REVISED SEWER CONNECTION		PERMIT APPLICATION (PRCNC20251558)	
No.	Date	By	Appr.
2	2/14/2026	KDM	CWV
1	1/20/2026	TEE	CWV

Title: TRASH ENCLOSURE OVERALL SITE PLAN FOR BLDG 1015

For: BENAROYA CAPITAL, LLC
CENTERIS DATA CENTERS
9675 SE 36TH ST, SUITE 115
MERCER ISLAND, WA 98040

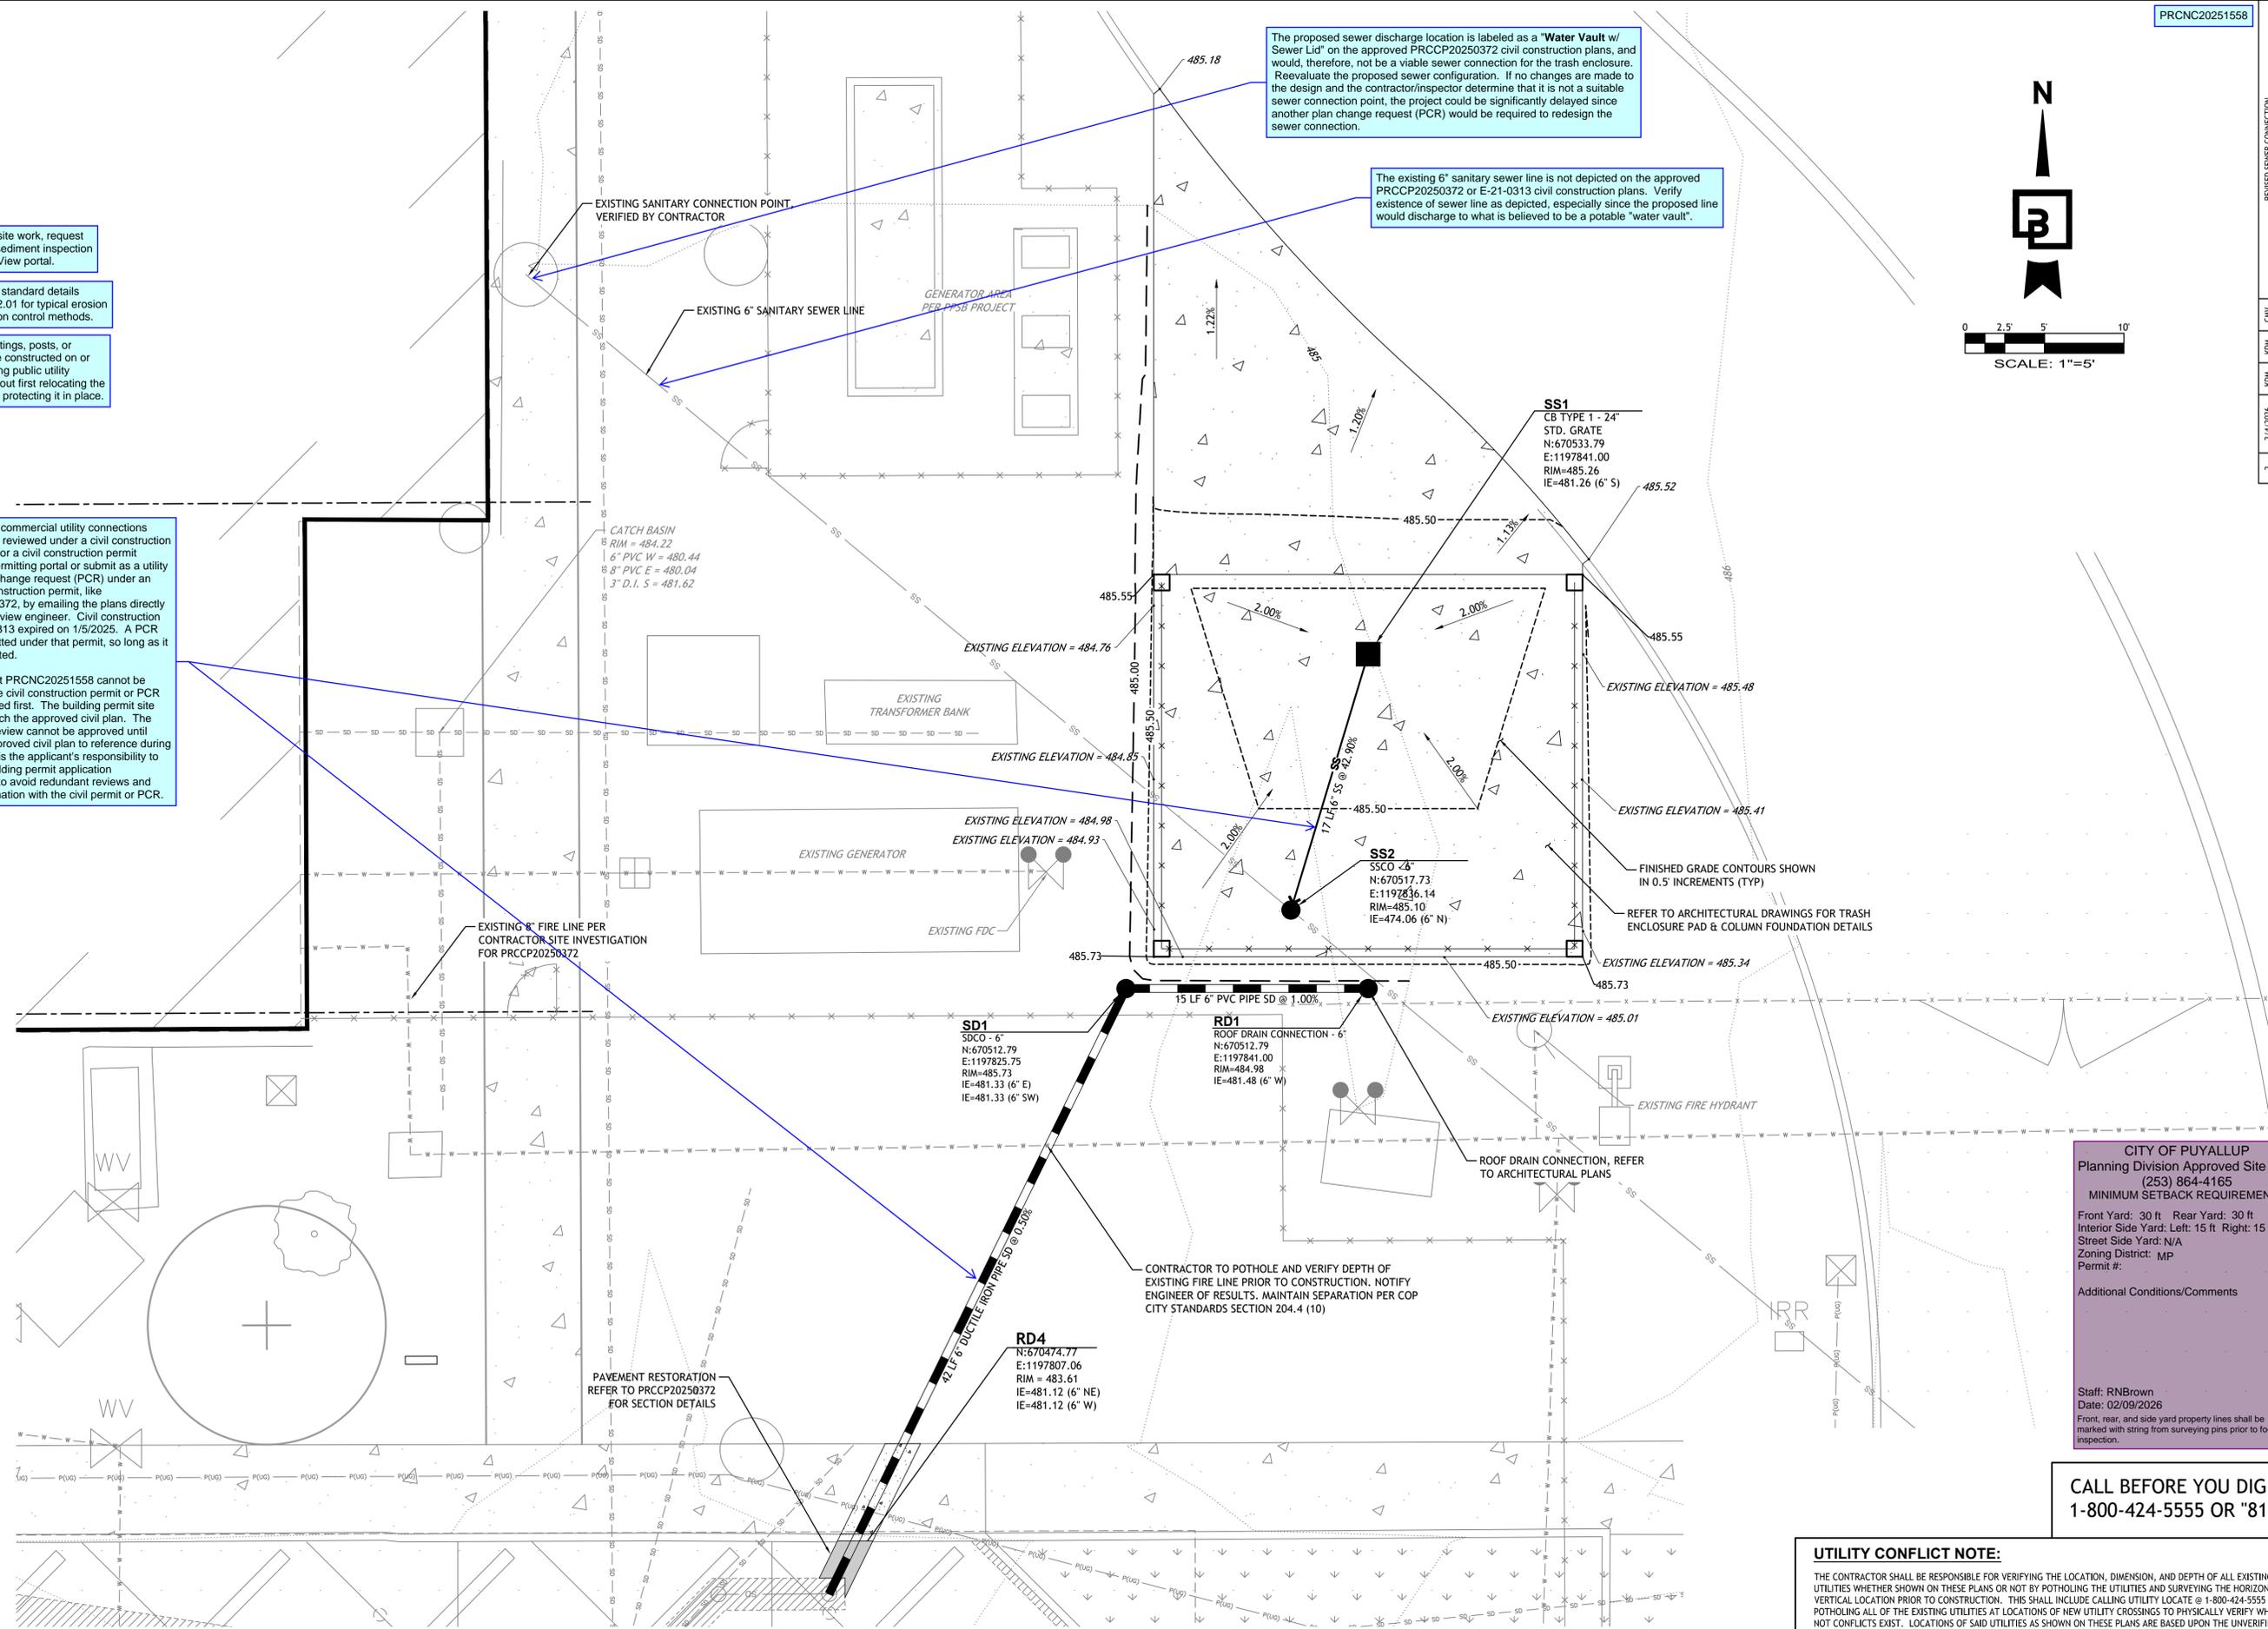
No proposed footings, posts, or supports shall be constructed on or above any existing public utility connections without first relocating the utility services or protecting it in place.

The proposed commercial utility connections have not been reviewed under a civil construction permit. Apply for a civil construction permit through the permitting portal or submit as a utility revision plan change request (PCR) under an issued civil construction permit, like PRCCP20250372, by emailing the plans directly to the City's review engineer. Civil construction permit E-21-0313 expired on 1/5/2025. A PCR may be submitted under that permit, so long as it can be reinstated.

Building permit PRCNC20251558 cannot be issued until the civil construction permit or PCR issued/approved first. The building permit site plan must match the approved civil plan. The Engineering review cannot be approved until there is an approved civil plan to reference during the review. It is the applicant's responsibility to coordinate building permit application resubmission to avoid redundant reviews and fees in coordination with the civil permit or PCR.

The proposed sewer discharge location is labeled as a "Water Vault w/ Sewer Lid" on the approved PRCCP20250372 civil construction plans, and would, therefore, not be a viable sewer connection for the trash enclosure. Reevaluate the proposed sewer configuration. If no changes are made to the design and the contractor/inspector determine that it is not a suitable sewer connection point, the project could be significantly delayed since another plan change request (PCR) would be required to redesign the sewer connection.

The existing 6" sanitary sewer line is not depicted on the approved PRCCP20250372 or E-21-0313 civil construction plans. Verify existence of sewer line as depicted, especially since the proposed line would discharge to what is believed to be a potable "water vault".
